Merged Document Report

Application No.: PL8819

PLAT OF SOUTHSIDE STORAGE TRACT BLOCK 1, LOT 1

UTILITY PLAN FOR SOUTHSIDE STORAGE TRACT BLOCK 1, LOT 1

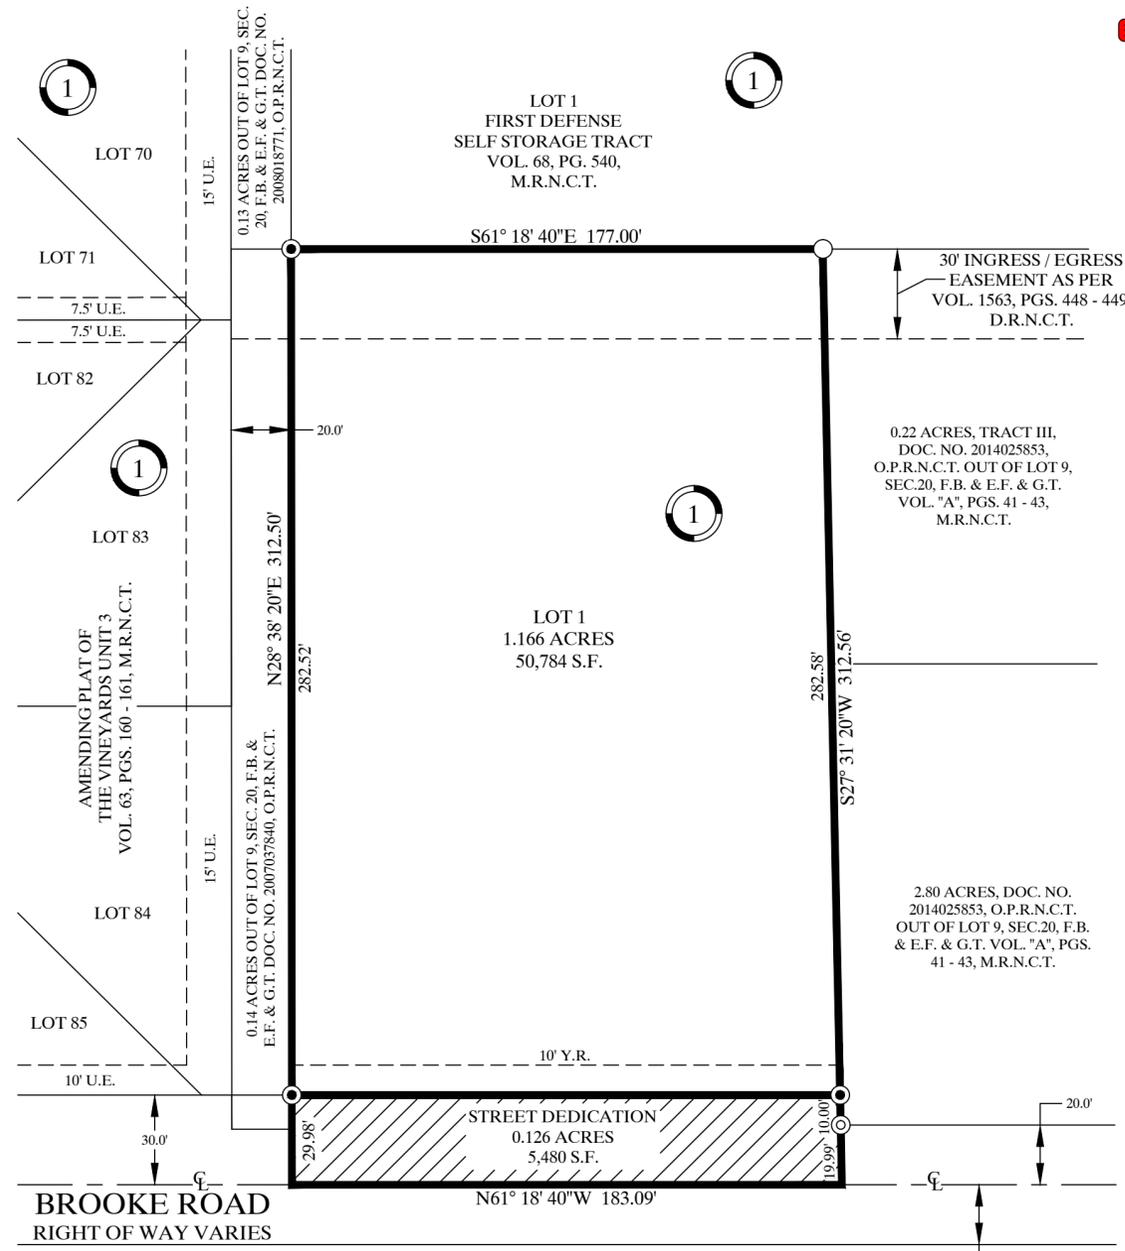
Comment ID	Page Reference	Annotation Type	Author : Department	Status	Review Comments	Applicant Response Comments
2	Plat	Note	Mina Trinidad : DS	Closed	(Informational) CCRTA: This plat is not located along any existing or foreseeably planned CCRTA service route.	
3	Plat	Note	Mina Trinidad : DS	Closed	(Informational) GIS: Plat closes within acceptable engineering standards.	
7	Plat	Note	Mina Trinidad : DS	Closed	<p>(Informational) Traffic/ROW:</p> <ol style="list-style-type: none"> 1. Proposed driveway access to a public City Street shall conform to access management standards outlined in Article 7 of the UDC (UDC 7.1.7) 2. Proposed driveway access to a public maintained by the Texas Department of Transportation (TXDOT) shall conform to TXDOT criteria. The developer and/or agent is responsible for coordination with the local TXDOT Area Office. 3. The PW-Traffic Department(Right-of-Way Division) is responsible for reviewing and permitting new construction and repairs/modifications to driveways, sidewalks, and curb and gutter. The review and approval of the permit must be approved prior to the issuance of the building permit (issued by DSD). (Refer to Municode Chapter 49-30 for permit requirements.) 4. A ROW Construction Permit, issued by PW-Traffic Department (Right-of-Way Division), is required for any work obstructing, closing, or occupying public right-of-way (Reference Chapter 49-2). Work within the Right-of-Way without a permit is subject to daily Non-Compliance Fees (Reference Municode Chapter 49). 5. Provide the PHT form using 11th edition, or latest edition, of the Trip Generation Manual . A PHT Form is required for any rezoning, site plan or street closure request for developments that are projected to contain 500 or fewer weekday peak hour trips. A traffic impact analysis will be required for developments generating or 501 trips. (Reference UDC Section 3.29) 6. An Urban Transportation Plan Amendment is required to modify or delete a master planned street. Coordinate with the Traffic Department (TrafficEngineering@cctexas.com) to complete this separate process and requirements. 7. Any street excavation, utility cut, or utility tap requires a permit issued by the Traffic Department (Right-of-Way Division). Restoration requirements are subject to the street Pavement Condition Index

Comment ID	Page Reference	Annotation Type	Author : Department	Status	Review Comments	Applicant Response Comments
					(PCI) and street age. New streets (Any street 0-6 years and / or PCI ≥ 80) will require restoration of 25-ft beyond the outermost edge of the excavation and up to curb to curb repair. Older streets (Any street > 6 years or PCI < 80) will require restoration of 10-ft beyond the outermost edge of the excavation and up to full lane (Refer to Municode Section 49-47-1). 8. Sidewalks required on both sides of local street as per IDM Chapter 6 - Street Design Requirements. Table 6.2.2 Street Right-of-Way Dimension Standards	
8	Plat	Note	Mina Trinidad : DS	Closed	(Informational) Parks and Recreation: No fees as plat is describing the construction of a restroom on a commercial plot. No proposed residential dwelling unit on site, and as such no fees are to be applied.	
9	Plat	Note	Mina Trinidad : DS	Closed	(Informational) Public Works Streets: 1. PW STR: Informational - Please refer to City of Corpus Christi Standards and Specifications for proposing roadwork, curb and gutter, sidewalk, utilities, etc and have the standards included in the plan set and the specifications referenced. Wherever available, please include a table of contents for which standards and specifications were used. 2. PW STR: Informational - A person shall be held responsible for damage to and in public right-of-way for the criteria outlined in Sec. 49-39-9 in the City's Municipal Code and will be held responsible for restoring the City assets per Municipal Code Sec. 49-47-1, Sec. 49-54-6 and Sec. 49-49-3. For further information, please email ROWManagement@cctexas.com.

10	Plat	Note	Mina Trinidad : DS	Closed	(Informational) Fire: Comments 1-8 1. Note: All code reference is based on currently adopted International Fire Code (IFC) 2021 and Corpus Christi Water Distribution Standards. 2. Plat Comments states that site will be used for commercial purposes. Therefore, plat review will be focused on requirements for commercial buildings. 3. Commercial Development shall have a fire flow of 1,500 GPM with 20 psi residual Fire hydrant every 300 feet and operational. 4. 507.5.1 (amendment) Where Required: All premises, other than one-family detached

Comment ID	Page Reference	Annotation Type	Author : Department	Status	Review Comments	Applicant Response Comments
					<p>dwellings, where buildings or portions of buildings are located more than 150 feet from a fire hydrant shall be provided with approved on-site hydrants and water mains capable of supplying the fire flow require by the fire official. The minimum arrangement being so as to have a hydrant available for distribution of hose to any portion of building on the premises at distances not exceeding 300 feet.</p> <p>5. 507.5.4 Obstruction. Unobstructed access to fire hydrants shall be maintained at all times. The fire department shall not be deterred or hindered from gaining immediate access to fire protection equipment or fire hydrants. Note: Hose lay from a hydrant will not cross an arterial street.</p> <p>6. 912.2.3 (amendment) Proximity to Hydrant: Fire department connections (FDC) for each sprinkler system or standpipe system shall be located not more than 100 feet from the nearest fire hydrant connected to an approved water source</p> <p>7. 503.1.1 (amendment) Buildings and facilities: Approved fire apparatus access roads shall be provided for every facility, building, or portion of a building hereafter constructed or moved into or within the jurisdiction. The fire apparatus access road shall allow access to three (3) sides of buildings in excess of fifteen thousand (15,000) square feet and all sides for buildings in excess of thirty thousand (30,000) square feet.</p> <p>8. 3310.1 Required access. Approved vehicle access for firefighting shall be provided to all construction or demolition sites. Vehicle access shall be provided to within 100 feet of temporary or permanent fire department connections. Vehicle access shall be provided by either temporary or permanent roads, capable of supporting vehicle loading under all weather conditions. Vehicle access shall be maintained until permanent fire apparatus access roads are available.</p>

11	Plat	Note	Mina Trinidad : DS	Closed	<p>(Informational) Fire: Comments 9-17</p> <p>9. D102.1 Access and loading. Facilities, buildings, or portions of buildings hereafter constructed shall be accessible to fire department apparatus by way of an approved fire apparatus access road with an asphalt, concrete or other approved driving surface capable of supporting the imposed load of fire apparatus weighing at least 75,000 pounds.</p> <p>10. 503.1.1 (amendment) Buildings and facilities: During construction, when combustibles are brought on to the site in such quantities as deemed</p>

Comment ID	Page Reference	Annotation Type	Author : Department	Status	Review Comments	Applicant Response Comments
					<p>hazardous by the fire official, access roads and a suitable temporary supply of water acceptable the fire department shall be provided and maintained.</p> <p>11. Note: An accessible road and a suitable water supply is required once construction materials are brought on site.</p> <p>12. 503.2.1 Dimensions. Fire apparatus access roads shall have an unobstructed width of not less than 20 feet, exclusive of shoulders and an unobstructed vertical clearance of not less than 13 feet 6 inches.</p> <p>13. D103.1 Access road width with a hydrant. Where a fire hydrant is located on a fire apparatus access road, the minimum road width shall be 26 feet, exclusive of shoulders.</p> <p>14. The minimum required width of 20 feet that shall be maintained means a clear unobstructed path that allows the passage of fire apparatus. 1. Where Fire Apparatus Access is constructed to the minimum of 20 feet, no parking is allowed within the fire apparatus lane. 2. Where a fire hydrant is located on the street, the minimum unobstructed clearance shall be 26 feet. In this instance, no parking is allowed on one side of the street. 3. The minimum UDC residential street width is 28 ft. curb to curb. Any parking along the street that reduces the width to less than 20 ft. is prohibited and the Fire Code Official and will require painting "NO PARKING-FIRE LANE" along one side of the street.</p> <p>15. Note: Calculated Turning Radii for Fire Apparatus: Inside Turn: 20 ft. 3 in. Curb to curb: 36 ft. 8 in. Wall to wall: 44 ft. 8 in. Note: The turning radius for fire apparatus should not be less than 45 degrees and curb to curb 36 feet. As a result, developers should be particularly careful not to design streets with acute angles that would prevent fire apparatus from completing a turn without having to back up to negotiate the turn.</p> <p>16. D105.1 Where required. Where the vertical distance between the grade plane and the highest roof surface exceeds 30 feet, approved aerial fire apparatus access roads shall be provided. For purposes of this section, the highest roof surface shall be determined by measurement to the eave</p>

Comment ID	Page Reference	Annotation Type	Author : Department	Status	Review Comments	Applicant Response Comments
					<p>of a pitched roof, the intersection of the roof to the exterior wall, or the top of parapet walls, whichever is greater</p> <p>17. D105.2 Width. Aerial fire apparatus access roads shall have a minimum unobstructed width of 26 feet, exclusive of shoulders, in the immediate vicinity of the building or portion thereof.</p>	
12	Plat	Note	Mina Trinidad : DS	Closed	<p>(Informational) Fire Comments 18-25</p> <p>18. D105.3 Proximity to building. At least one of the required access routes meeting this condition shall be located within a minimum of 15 feet and a maximum of 30 feet from the building and shall be positioned parallel to one entire side of the building. The side of the building on which the aerial fire apparatus access road is positioned shall be approved by the fire code official.</p> <p>19. D105.4 Obstructions. Overhead utility and power lines shall not be located over the aerial fire apparatus access road or between the aerial fire apparatus road and the building. Other obstructions shall be permitted to be placed with the approval of the fire code official.</p> <p>20. 503.4 Obstruction of fire apparatus access roads. Fire apparatus access roads shall not be obstructed in any manner, including the parking of vehicles. The minimum widths and clearances established in sections D103 shall always be maintained.</p> <p>21. 503.3 Marking: Where required by the fire code official, approved signs, or other approved notices the include the words NO PARKING-FIRE LANE shall be provided for fire apparatus access roads to identify such roads to prohibit the obstruction thereof. The designation of a fire lane can be marked with conspicuous signs which have the words:" Fire Lane-No Parking" at 50-foot intervals. In lieu of signs, fire lanes may be marked along curbing with the wording, "Fire Lane-No Parking" at 15-foot intervals.</p> <p>22. Table D103.4 Requirements for Dead-end fire apparatus access roads. Turnaround provisions shall be provided with a 96-foot diameter cul-de-sac.</p> <p>23. 503.2.5 Dead ends. Dead-end fire apparatus access roads more than 150 feet in length shall be provided with an approved area for turning around fire apparatus.</p> <p>24. D103.5 Fire apparatus access road gates. If</p>

Comment ID	Page Reference	Annotation Type	Author : Department	Status	Review Comments	Applicant Response Comments
					<p>installed-Gates securing the fire apparatus access roads shall comply with all the following criteria: Single gate width shall not be less than 20 feet. 12 foot gate width is required for a divided roadway. Electric gates shall be equipped with a means of opening the gate by fire department personnel for emergency access. Emergency opening devices shall be approved by the fire code official. Note: The use of a Knox Gate Switch is currently required by the Fire Official. Methods of locking shall be submitted for approval by the fire code official. Note: The Knox Padlock is currently required by the Fire Official. Electric gate operators, where provided, shall be listed in accordance with UL 325. Gates intended for automatic operation shall be designed, constructed, and installed to comply with the requirements of ASTM F 2200. Manually operated gates shall be secured with a Knox Pad Lock installed "daisy chain style" 25. Commercial development of the property will require further Development Services review.</p>

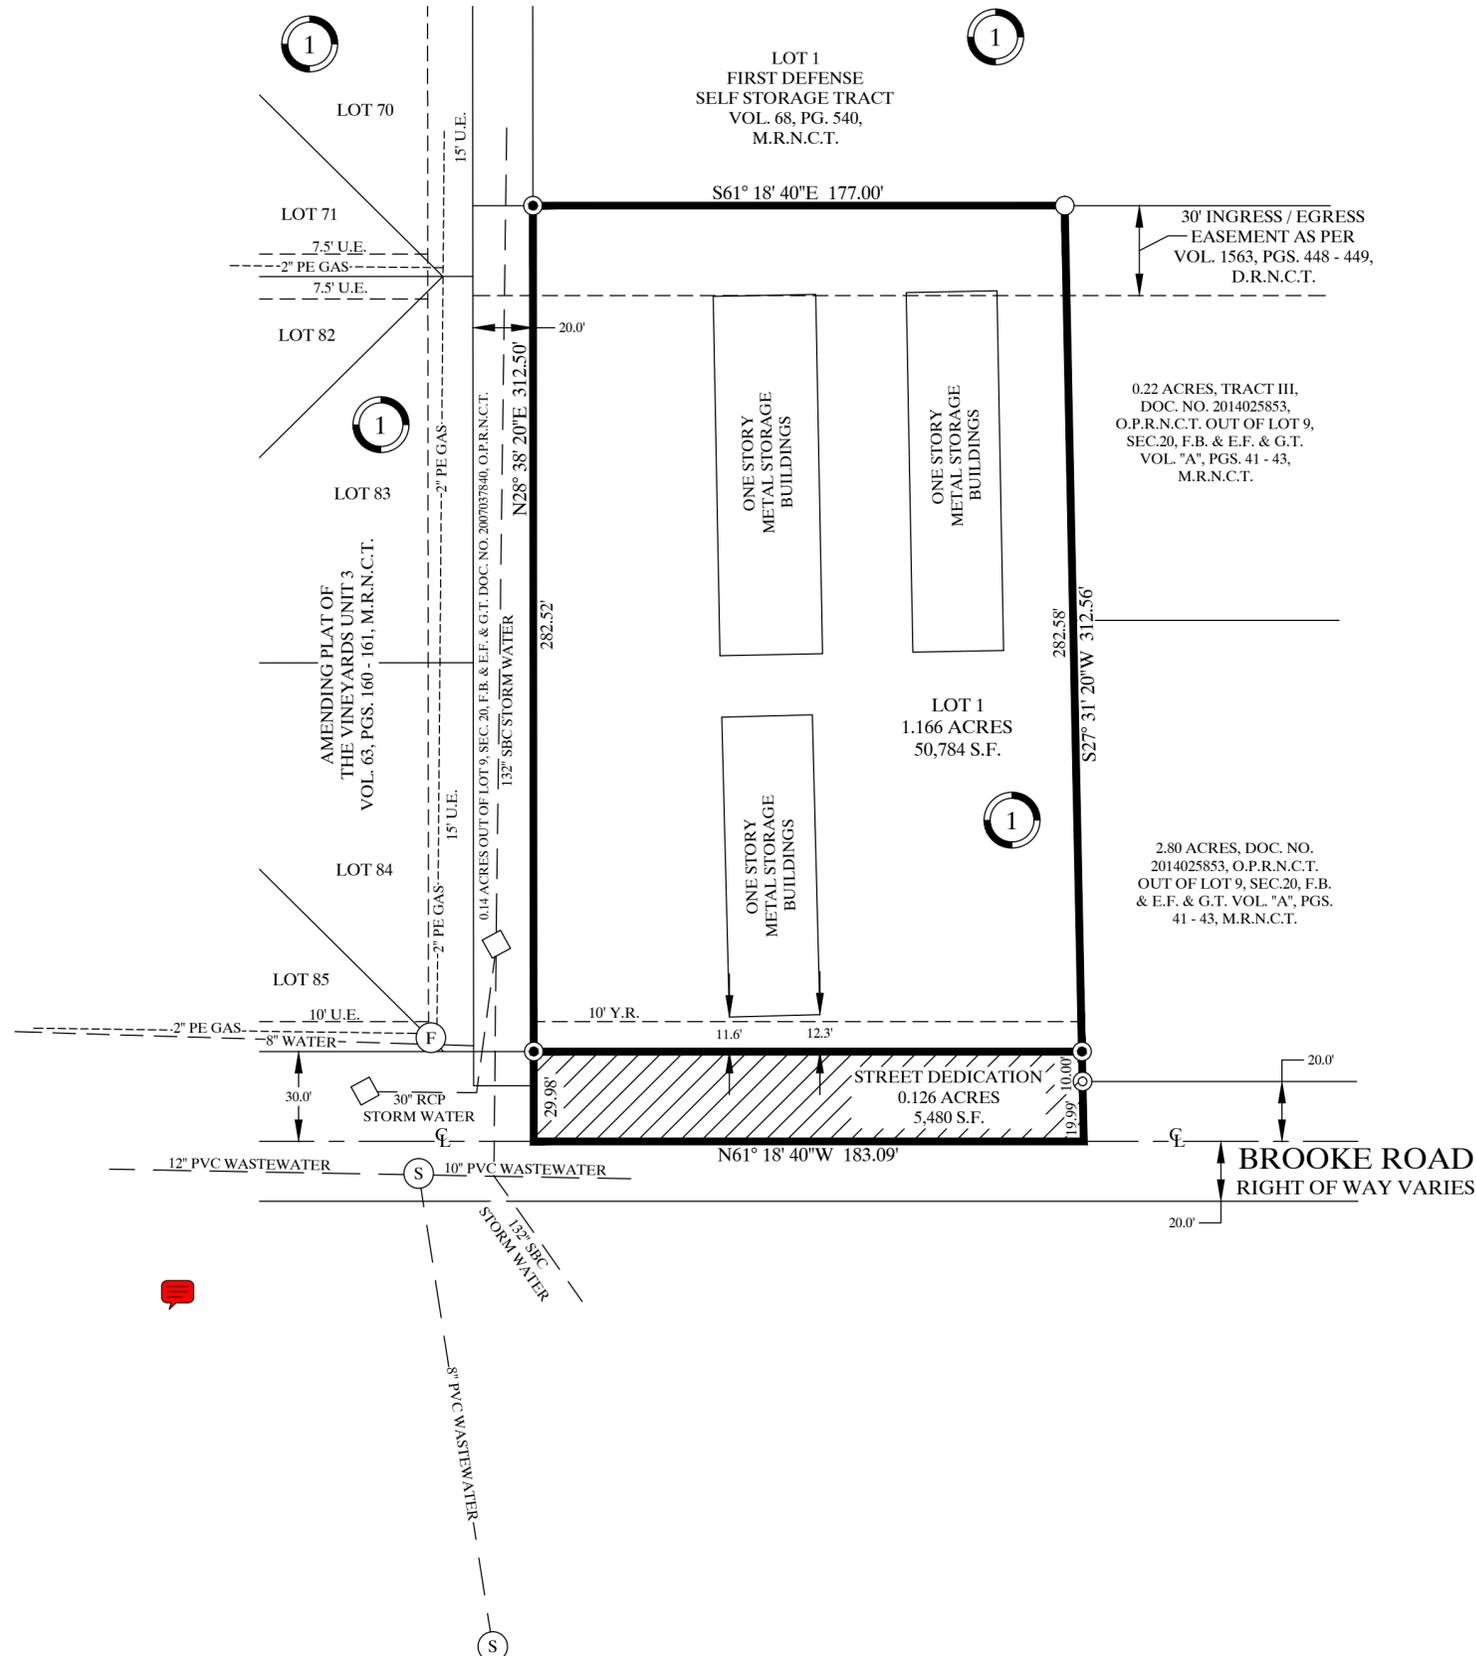
4	Utility Plan	Note	Mina Trinidad : DS	Closed	(Informational) AEP: AEP Texas Transmission has no comment for the subject plat.	
5	Utility Plan	Note	Mina Trinidad : DS	Closed	(Informational) Gas: The gas department has no comments for this plat.	
6	Utility Plan	Note	Mina Trinidad : DS	Closed	(Informational) AEP: AEP Texas Distribution has no comment.
